Gatwick Airport Northern Runway Project

Examination Ref: TR020005

Response to REP6-093] - 10.52.3 The Applicant's Response to Deadline 5 Submissions - Response to JLA's' EMG Framework Paper

Deadline 7: 15 July 2024

Figure 1: Heathrow Airport Slots Allocated against Declared Capacity (dotted line) for

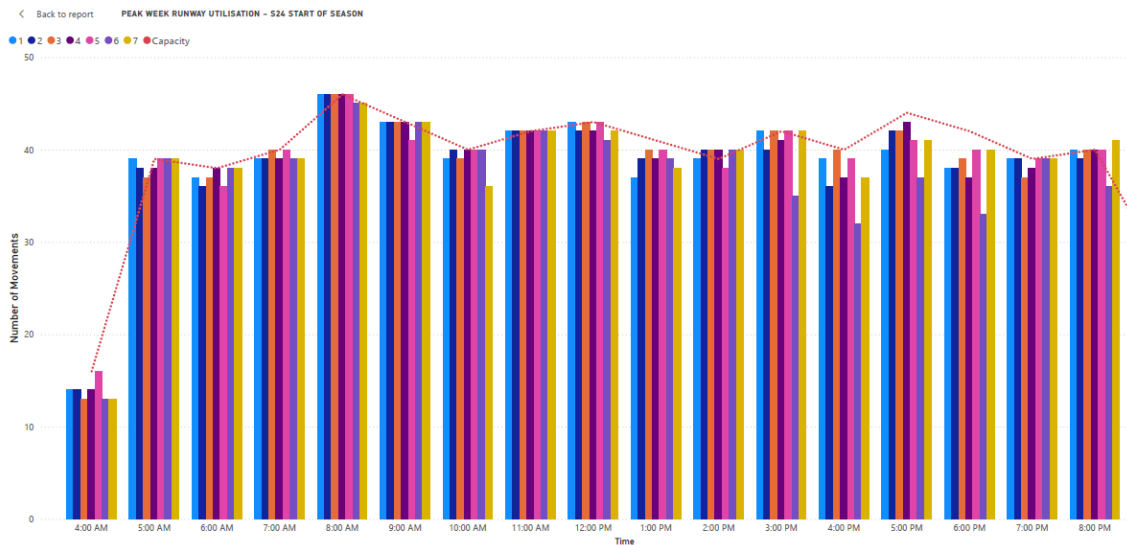
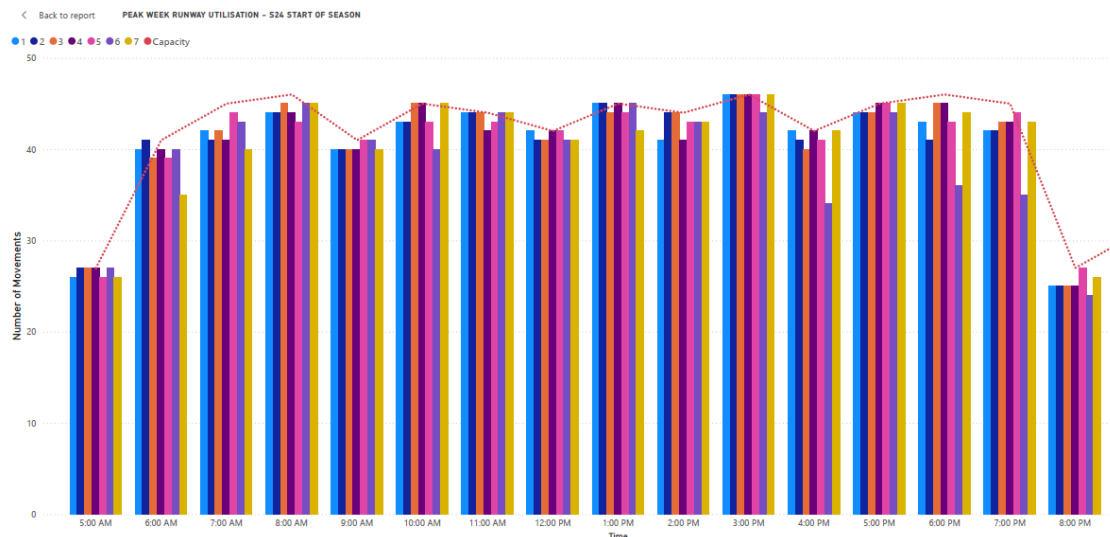
13. Ultimately, the key point is that any capacity declaration will necessarily have some headroom within it otherwise the process of slot allocation would not be workable and the Applicant cannot, in practice, micro-manage the process to the extent claimed. The availability of spare capacity is evident even at Heathrow, as illustrated in **Figure 1** overleaf despite the Airport operating at full capacity.
